CALIFORNIA COASTAL COMMISSION

REGULAR CALENDAR
STAFF REPORT AND PRELIMINARY RECOMMENDATION

Application No.: 6-10-041

Description: The construction of a 38,600 sq. ft. Marine Ecosystem Sensing, Observation, and Modeling (MESOM) research and education facility, including a three story laboratory, office, conference and support space, at a location currently utilized by two parking lots (Lot Nos. P012 & P013).

**VEGETATION MANAGEMENT
LOCATIONS**

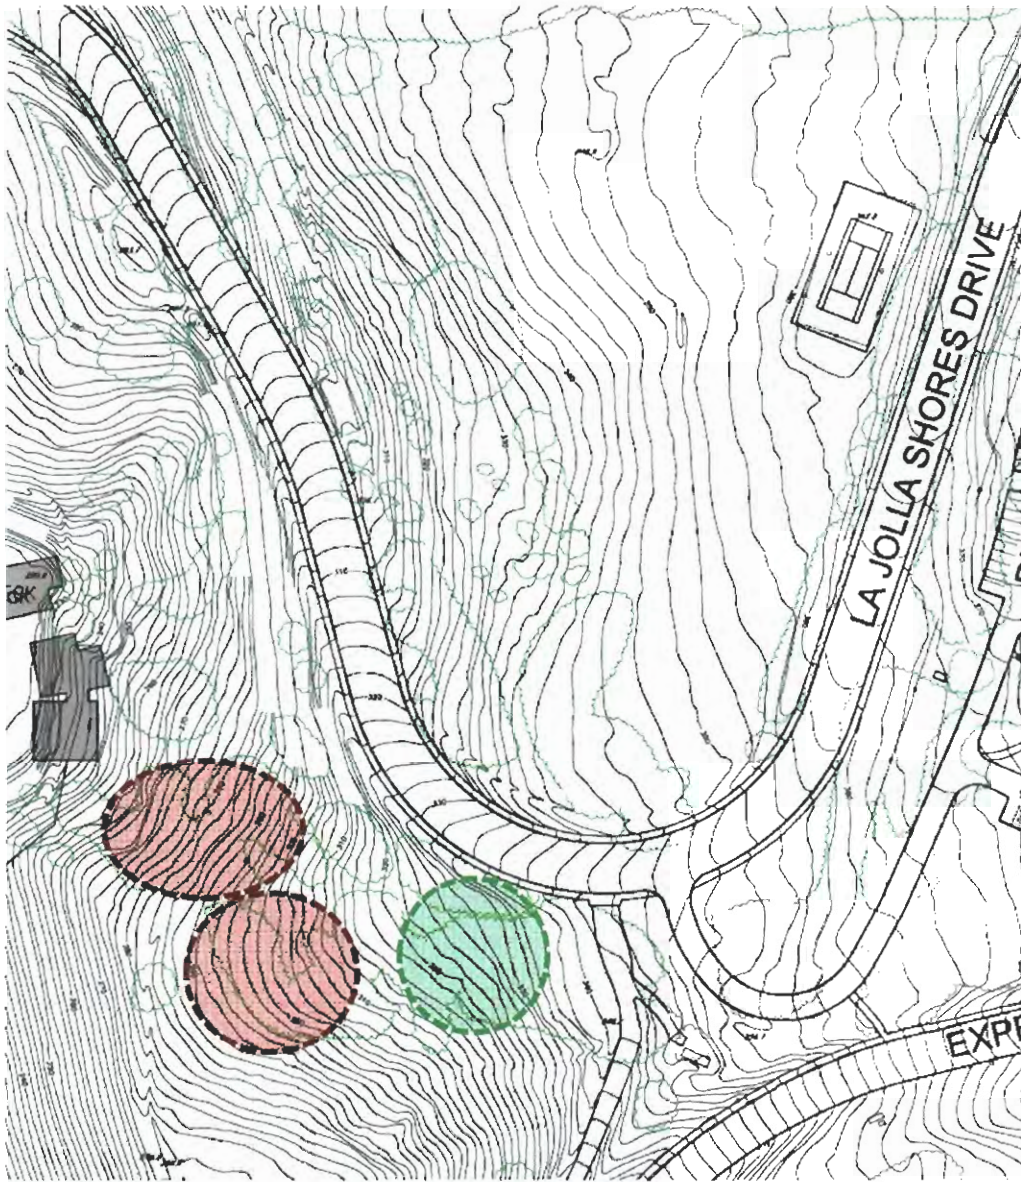
1. In those areas shown on the aerial photo attached as Exhibit #5.a and the accompanying street-level photos of particular vegetation also attached as Exhibit #5 subsections “b”-“g”, vegetation that interferes with views to La Jolla Cove, La Jolla Shores, the coast, and the ocean shall be removed and/or thinned. In some cases, subject to Executive Director approval, a limited amount of vegetation may be retained to “frame” existing coastal views.

3. The vegetation identified in attached Exhibit #5 for removal/thinning shall be removed/thinned prior to or concurrent with construction of the MESOM building.

1. Any new vegetation at the locations designated in Exhibit #5 may not exceed a height of 24 inches above ground level. Maintenance of cleared areas shall be included to maximize coastal views.

The third area proposed for vegetation removal is located towards the southern end of the SIO campus and is titled “South Scripps” (ref. Exhibit #5). At this location there are multiple ornamental trees and shrubs that currently obstruct views of La Jolla Cove and La Jolla Shores from La Jolla Shores Drive. At this location the University is proposing to remove the majority of trees and shrubs obstructing these views. However, in this case the University is proposing to maintain the coral trees that currently line La Jolla Shores Drive. Again, staff has visited this site and concurs that removing the vegetation, but maintaining the coral trees, would provide a framed vantage point and would not result in obstruction of the desired views. Again, while the trees and shrubs proposed for removal have been tentatively identified, Special Condition #1 requires the University to submit a final plan that is subject to the review and approval by the Executive Director that identifies the exact trees and shrubs to be removed.

CDP Application No. 6-10-41 Exhibit #7

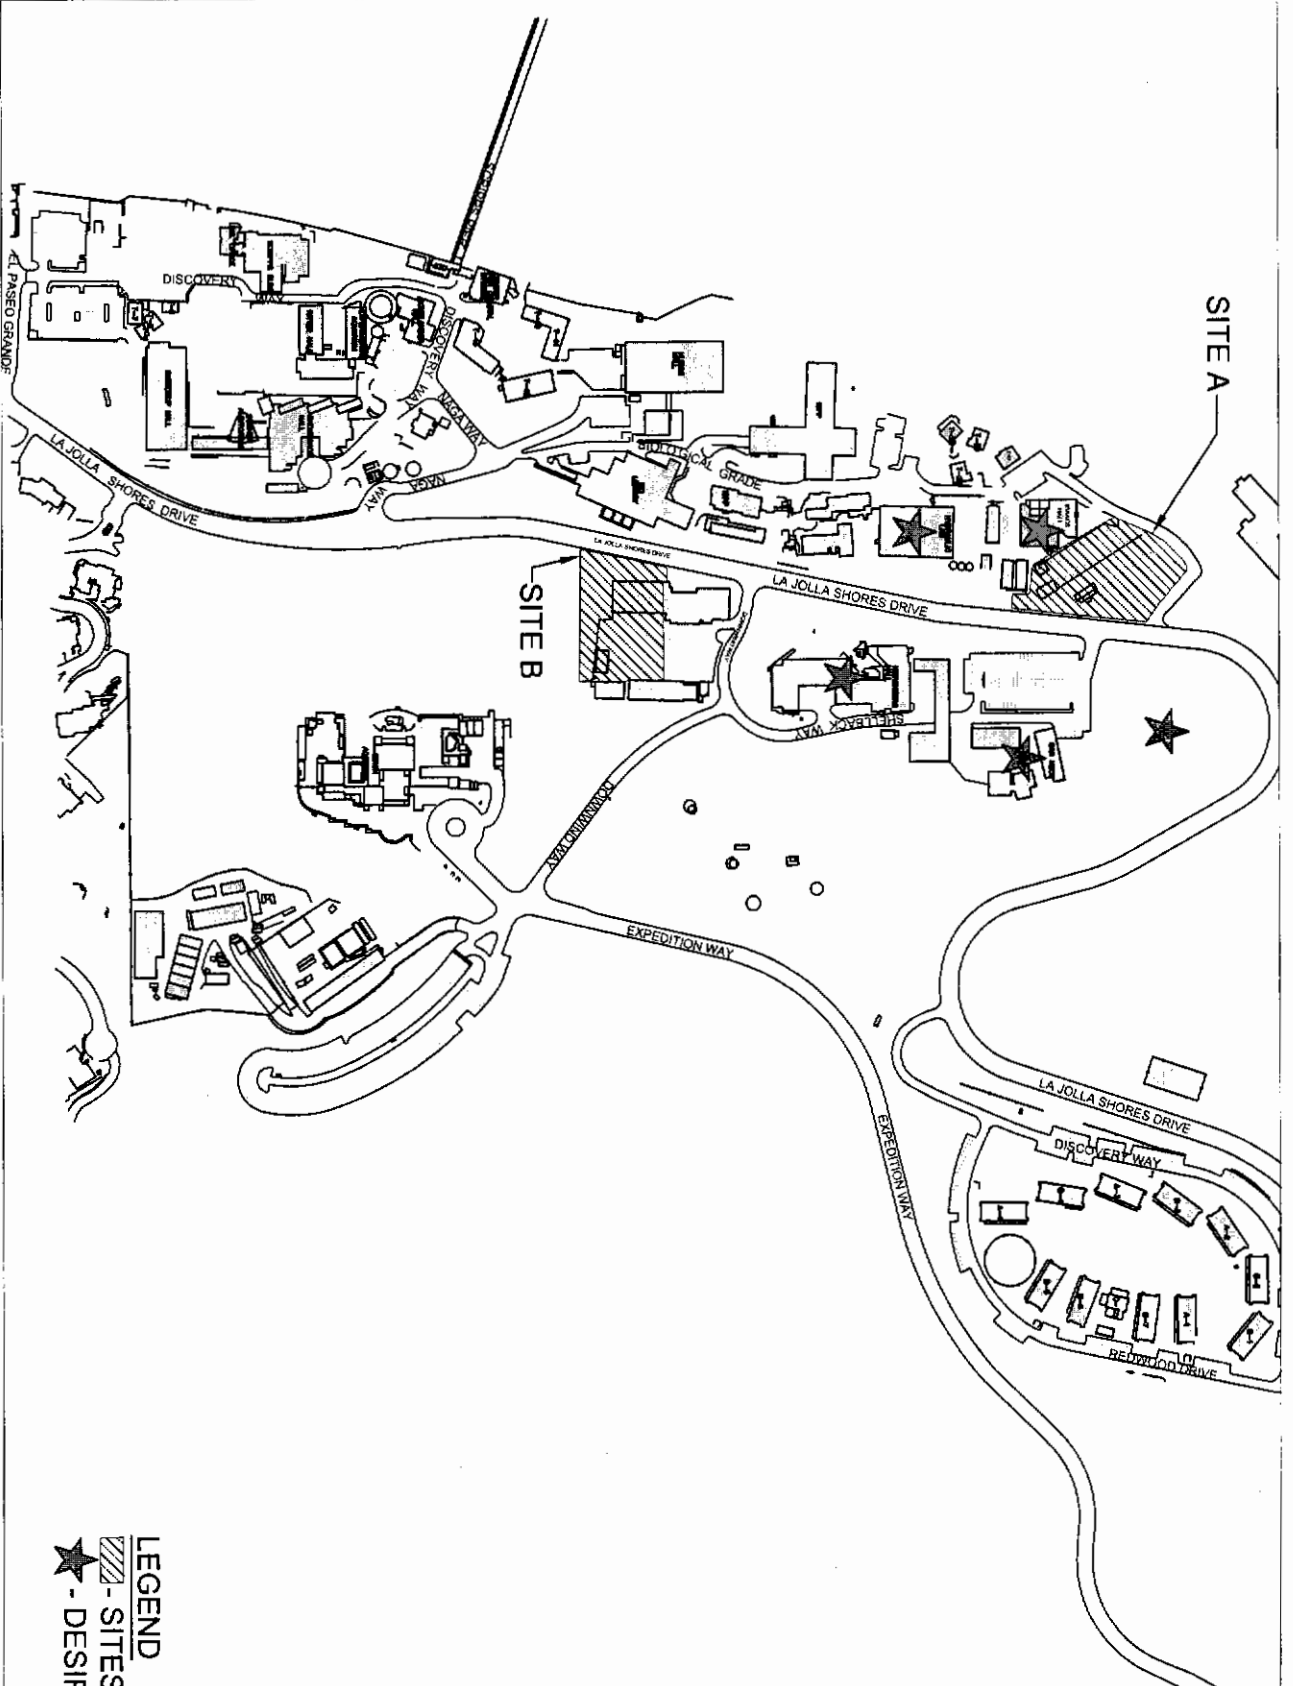
3. Restrictions on Future Development. **PRIOR TO THE ISSUANCE OF THE COASTAL DEVELOPMENT PERMIT**, the applicant shall enter into a Memorandum of Agreement (MOA) with the Commission regarding a future development plan for the Scripps Institution of Oceanography (SIO) campus. The MOA shall contain limits on future development of the SIO campus that are in substantial conformance with the plans proposed by the University of California San Diego through correspondence dated January 6, January 24, and March 1, 2011 and as depicted by attached Exhibit #7, and, at minimum, shall include the following:

3. Prior to undertaking any future redevelopment of buildings in this area, the applicant shall conduct a site-specific evaluation analysis for the existing building and that specific section of La Jolla Shores Drive adjacent to that building. The elevations of La Jolla Shores Drive (Above Mean Sea Level [AMSL]) as would be applicable for the height limitation on future development are generally depicted by attached Exhibit #7, entitled “Scripps

2. The existing buildings that shall be allowed to maintain their elevation above La Jolla Shores Drive are shown in attached Exhibit #7, entitled “Scripps Institution of Oceanography View Enhancement and Preservation Development Guidelines.” Specifically, the identified buildings, their accompanying sites, and the elevations of the existing structures are:

EXHIBIT NO. 8
APPLICATION NO.
6-10-041
Alternative Sites
Page 1 of 3
California Coastal Commission

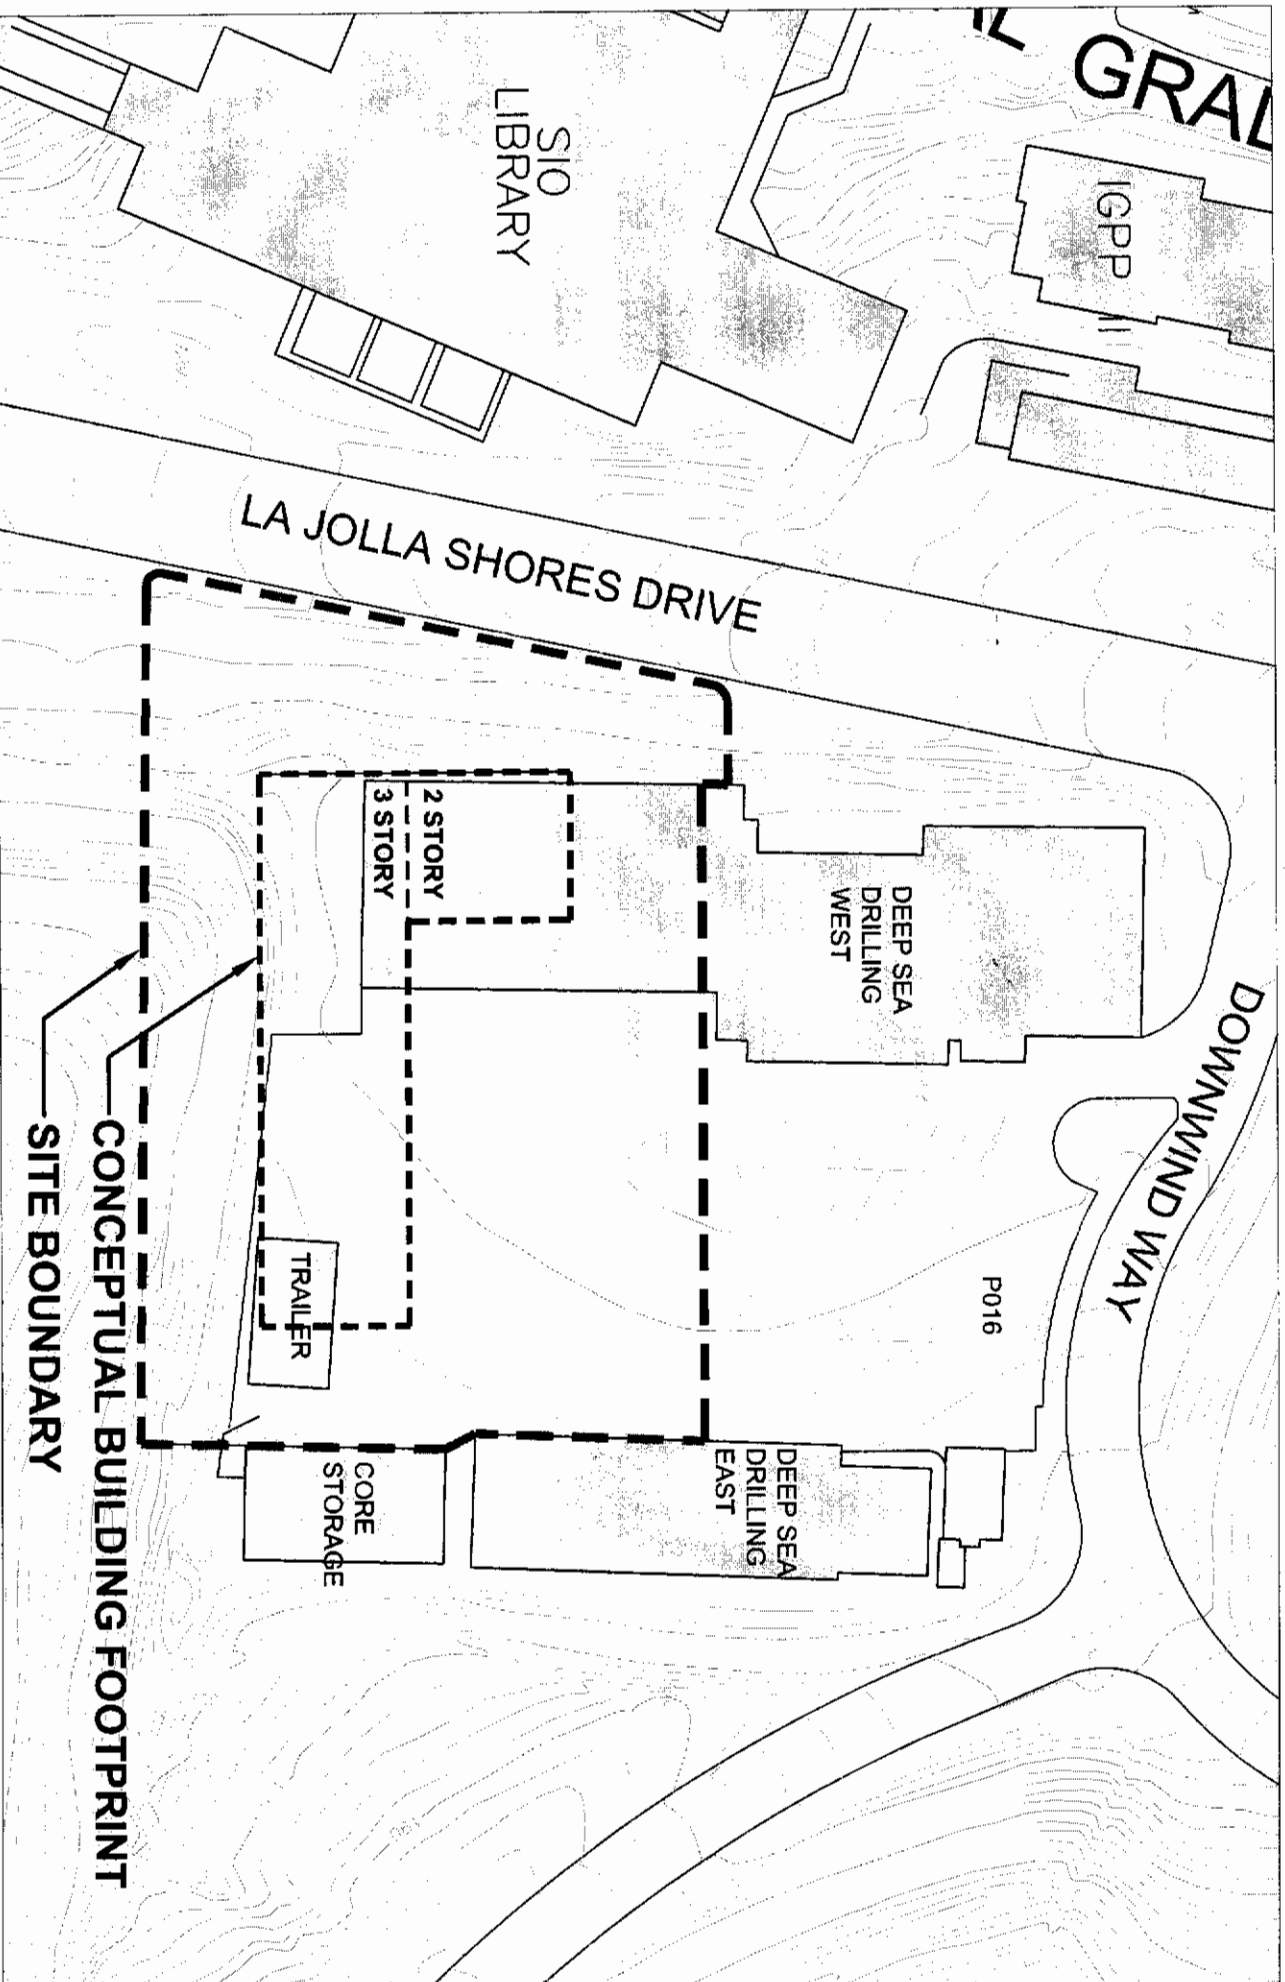
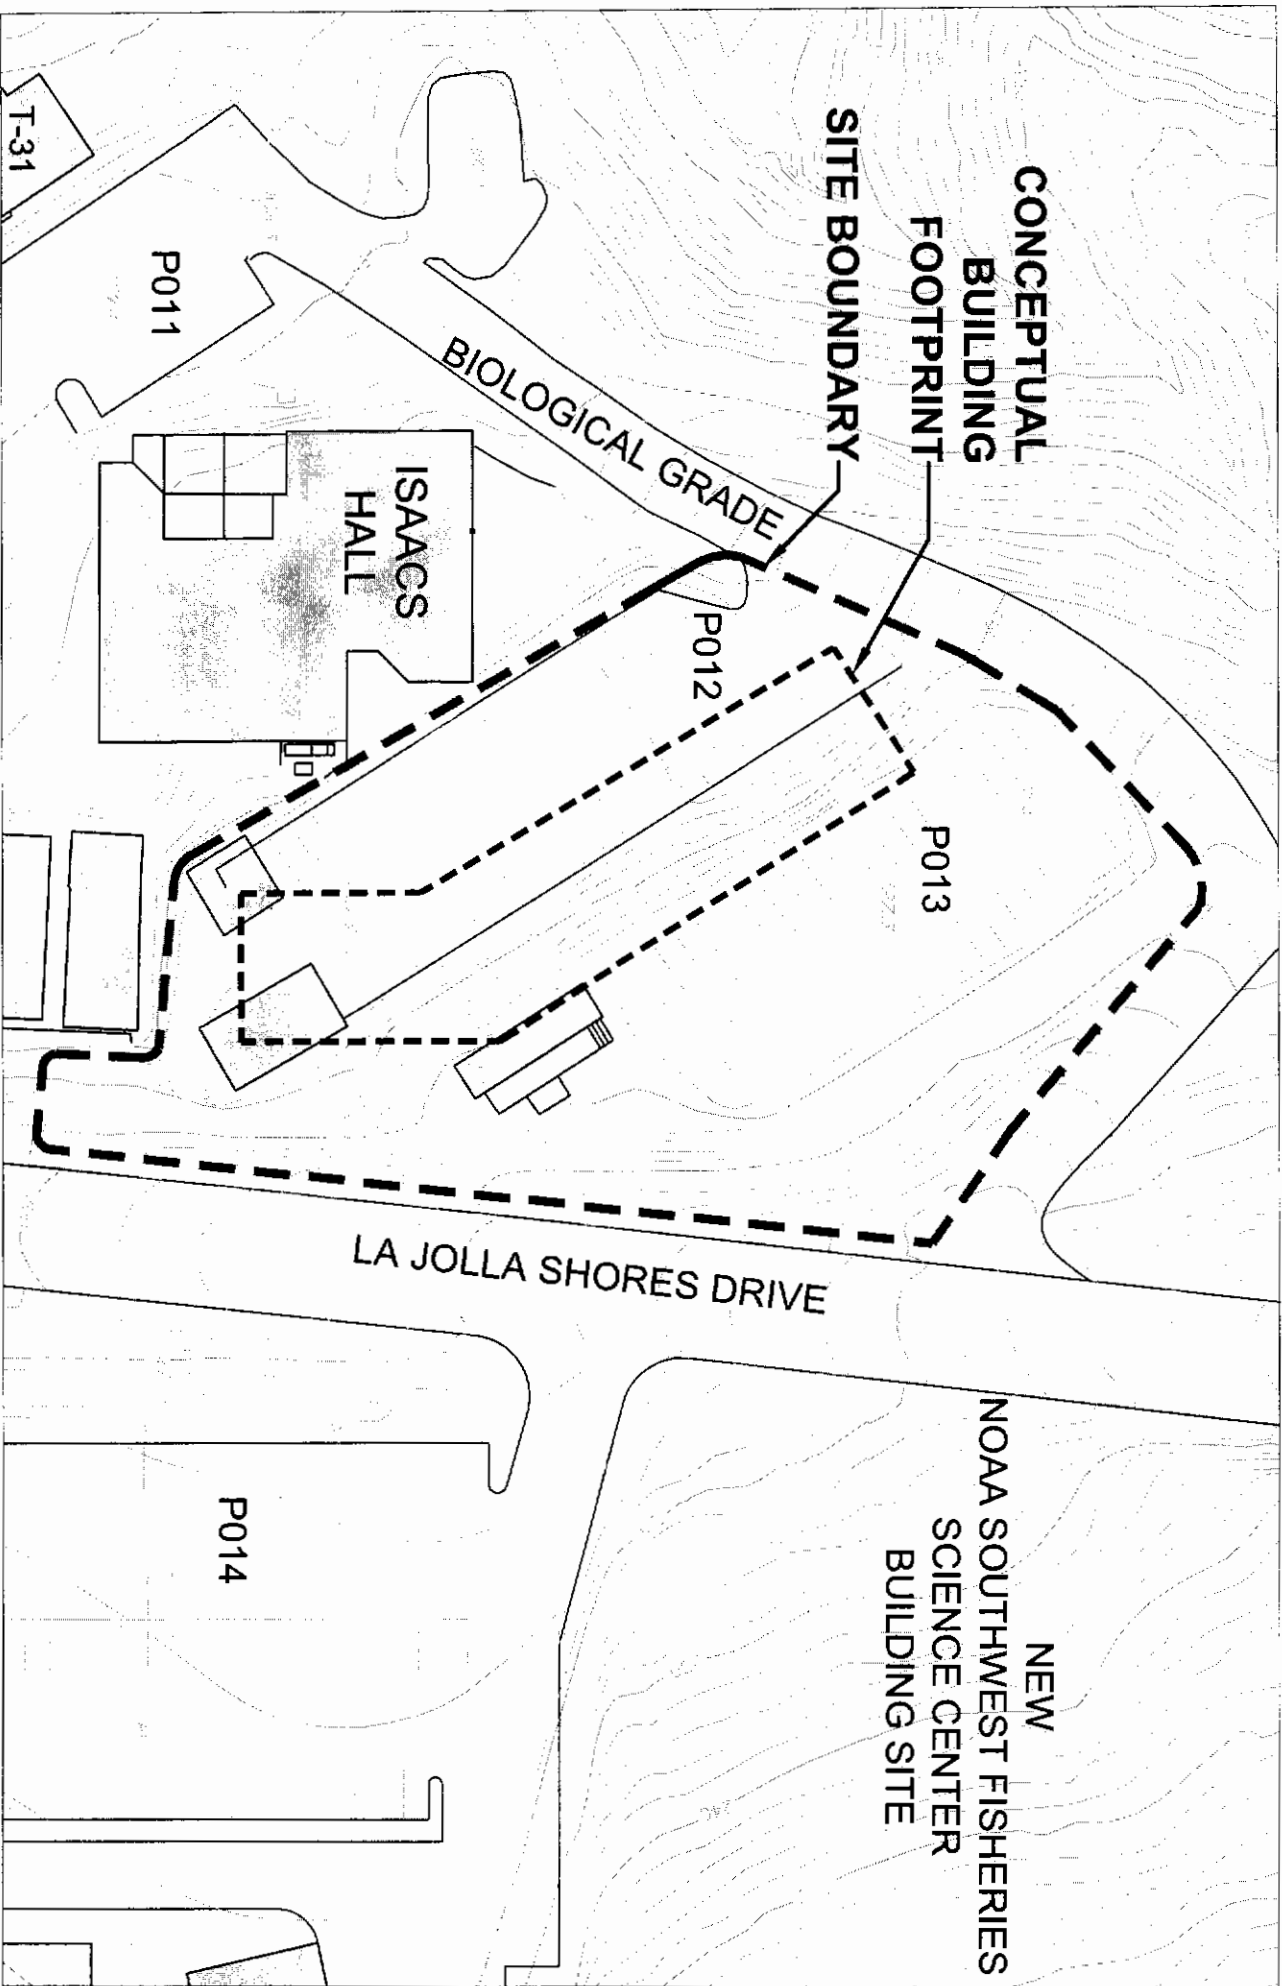
During the planning stages, UCSD reviewed two alternative sites for the MESOM building other than the proposed site. The first area reviewed was in the area of the Scripps Upper Mesa, and included a site south and west of Torrey Pines Road. However, this location was not within walking distance of the above mentioned buildings and thus would not provide the connectivity desired by the University. Additionally, there is no current seawater access, and thus the seawater access would have to be constructed at a cost of approximately \$4.1 Million. Lastly, the access for vehicles larger than 28 feet tall would be limited and would have to be constructed. This alternative site was therefore eliminated.

EXHIBIT NO. 9
APPLICATION NO.
6-10-041
Figure 9 of La Jolla
Shores Community
Plan

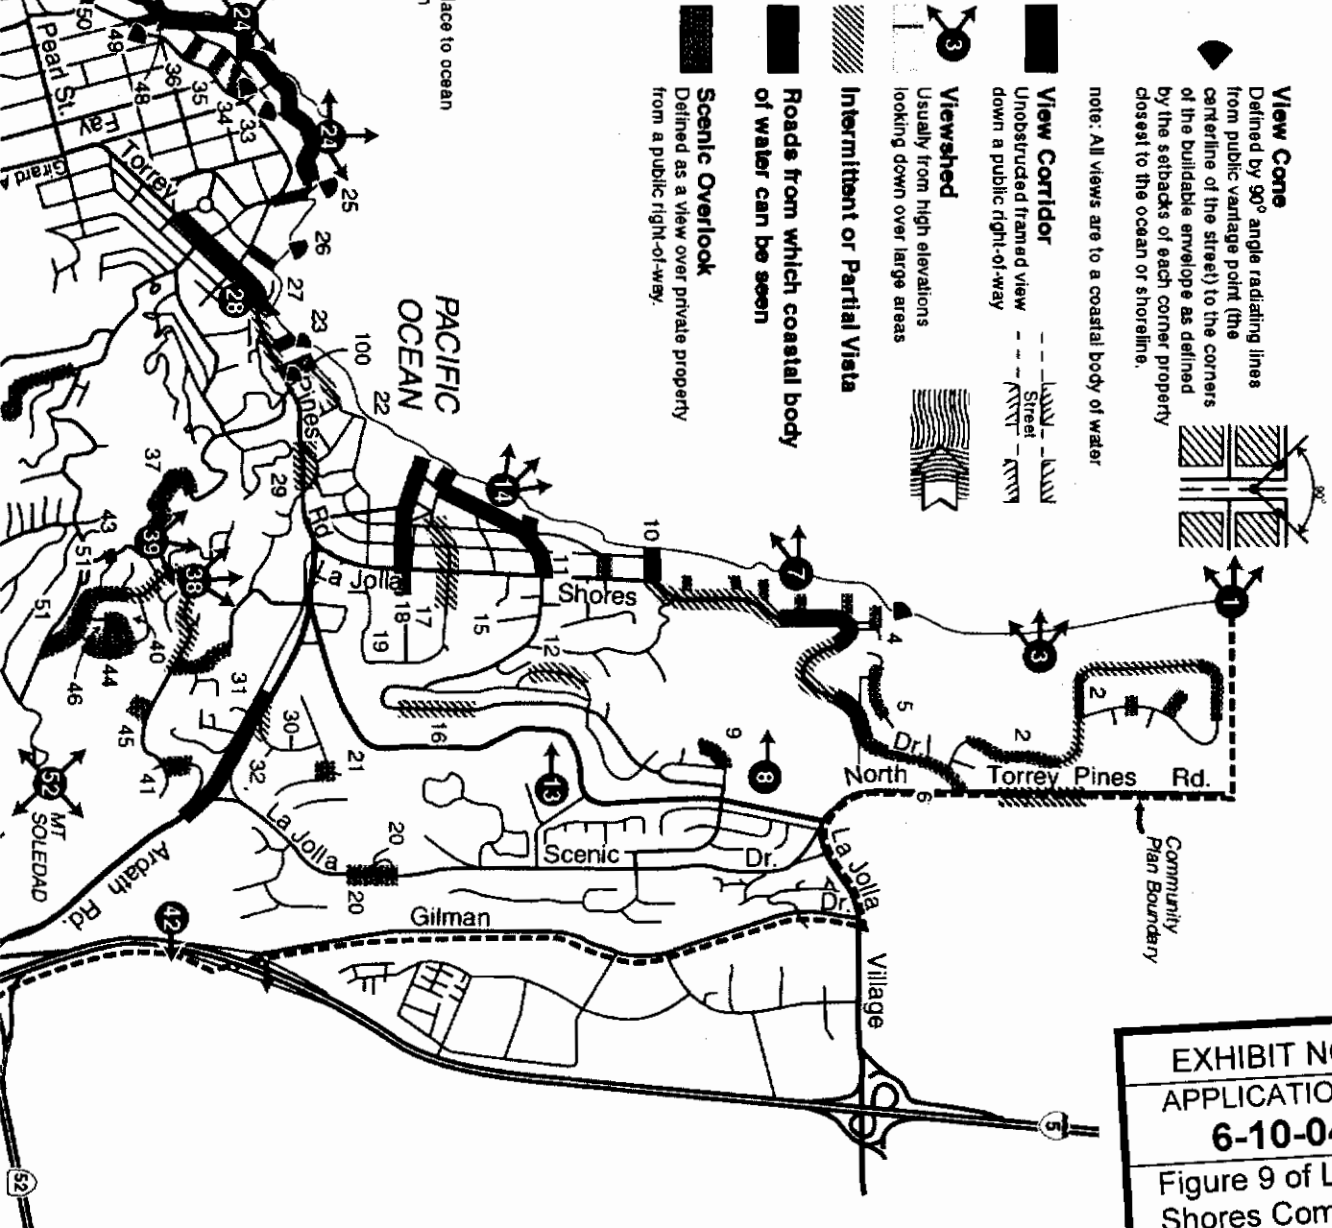
Figure 9 of the La Jolla Community Plan also identifies La Jolla Shores Drive as an area that contains scenic overlooks, intermittent or partial vistas, and is also considered to be a road from which the Pacific Ocean can be seen (ref. Exhibit #9).
